Re: Port of Seattle July 23, 2001 Low Streamflow Analysis

As you know, Northwest Hydraulic Consultants has been retained on behalf of the Airport Communities Coalition (ACC) to provide a technical review of stormwater facilities and related streamflow impacts from the proposed 3rd runway development at SeaTac airport. The purpose of this letter is to comment on the July 23, 2001 Port of Seattle two-volume document titled "Low Flow Analysis Flow Offset Facility Proposal." The comments here are in addition to the outstanding Stormwater Management Plan issues and uncertainties described in our letter of June 25, 2001, and summarized at our meeting on July 10, 2001.

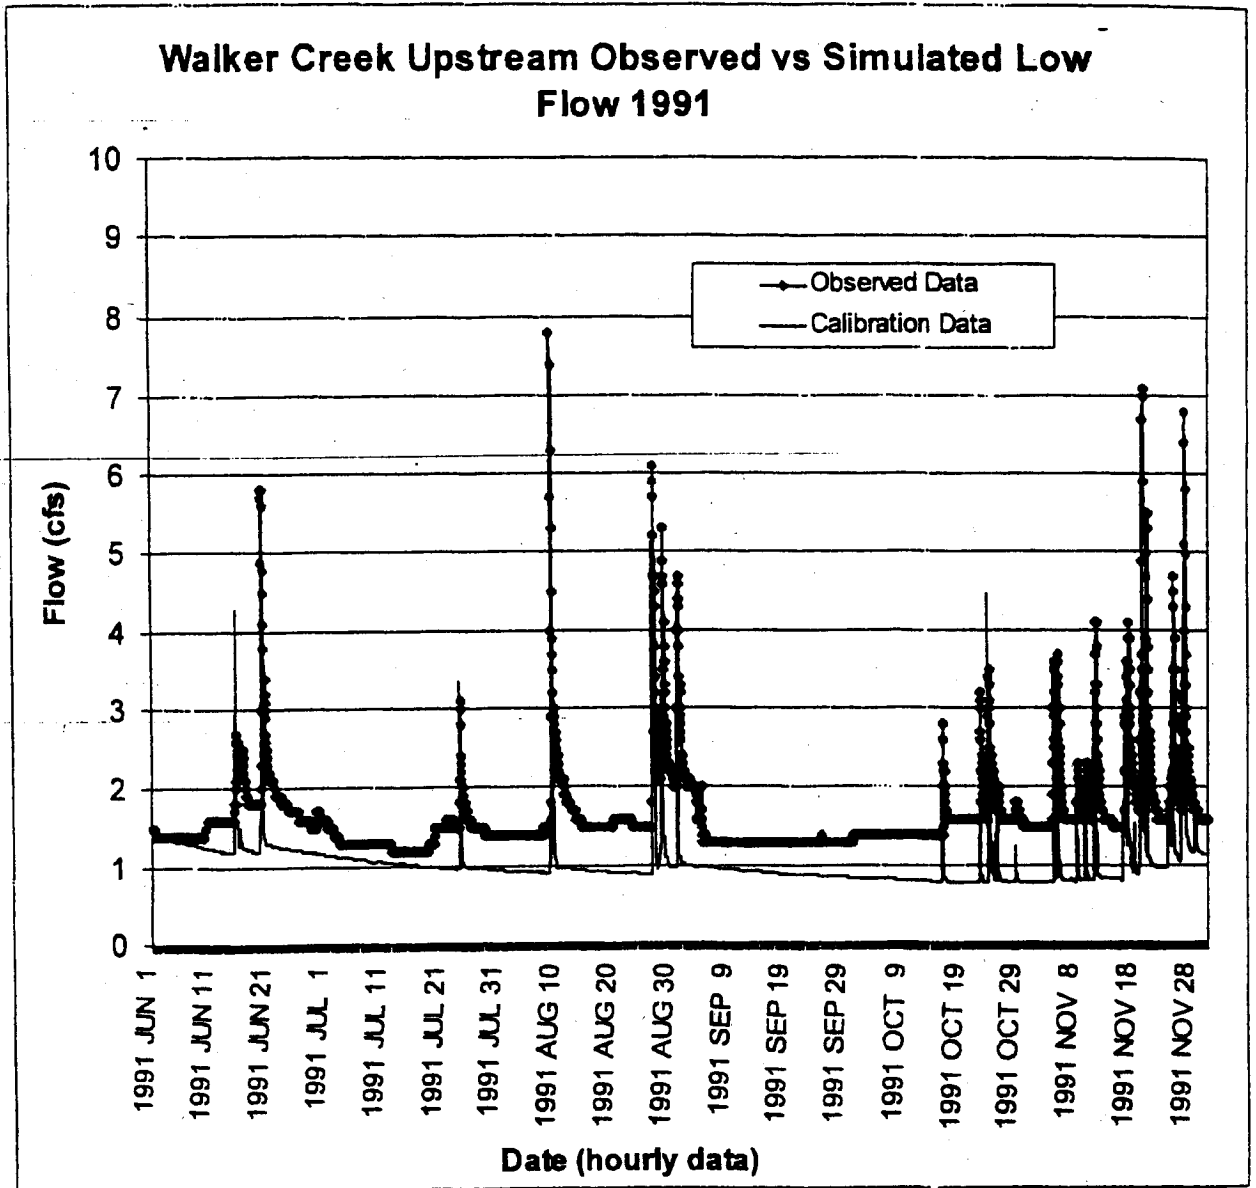
6. For Walker Creek, the calibration of simulated (HSPF) low flows to recorded low flows at the upper basin gage is very poor. HSPF simulation results for all calibration years (1991-1996) produce base flows which become progressively smaller from June through October, with the lowest flows of the year generally occurring in October. These simulation results formed the basis for the low flow analysis report finding that the summer low flow period for Walker Creek begins on August 1 and ends on October 31. However, this pattern and definition of low flow period is inconsistent with the actual streamflow record. The recorded data show that the lowest flows of the year actually occurred in June and/or July in half of the years with recorded data. In our opinion, definition of the low flow period should rely more on the actual data and less on the model data given that the calibration is so poor. Visual inspection of the recorded streamflow data for 1991-1996 suggests that the season where low flows are of concern should be extended to cover at least the period of July 1 through October 31. A comparison of Walker Creek simulated and recorded streamflows for 1991 is given in the figure below to illustrate the basis for this comment.

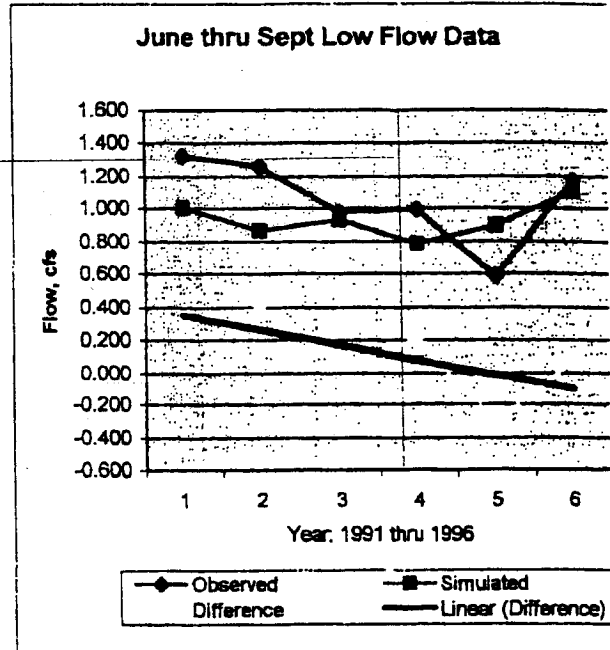
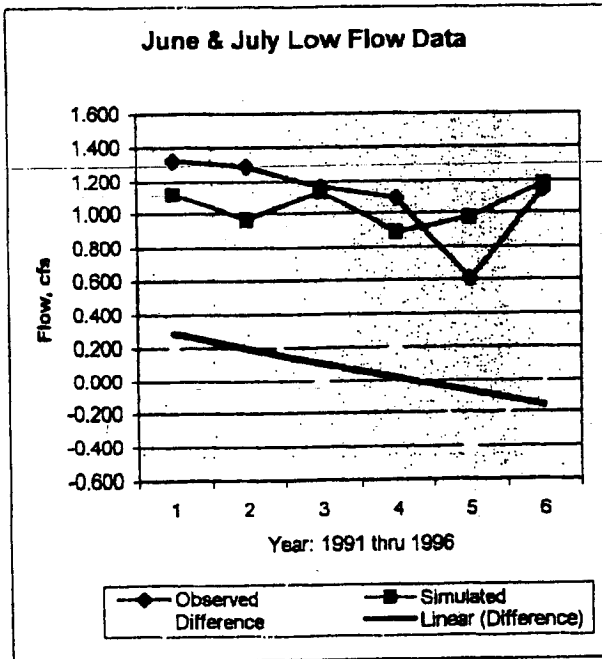
then differences between the recorded and simulated data for other years could indicate changes in basin conditions. We examined the average summer low flow at the upper basin gage for each year of record, to see if the recorded (actual) flows were changing relative to the simulated flows. For this evaluation, days with observed and/or computed flows greater than 1.5 cfs (representing surface runoff) were excluded from the calculation of average summer low flows. Average value for simulated and recorded low flows were computed for each year, and plotted as a time series. The results are shown below.

We have two alternative interpretations of these results. One interpretation is that there is a pronounced declining trend in the observed data relative to the simulated data for the same period.

The analysis shows that summer streamflows are declining independent of climatic variability, and that there has been an average summer low flow reduction of about 0.5 cfs over the period 1991 to 1996. The alternative interpretation is that the Walker Creek HSPF model calibration to low flows, in conjunction with uncertainty as to the quality of observed streamflow data, is too poor to draw any conclusions about anything. Under the first interpretation, the proposed low streamflow mitigation of 0.09 cfs for Walker Creek is probably insufficient to compensate for actual airport impacts. Under the second interpretation, there is substantial uncertainty as to whether the HSPF model is useful for assessing low streamflow impacts or devising a mitigation plan for Walker Creek.
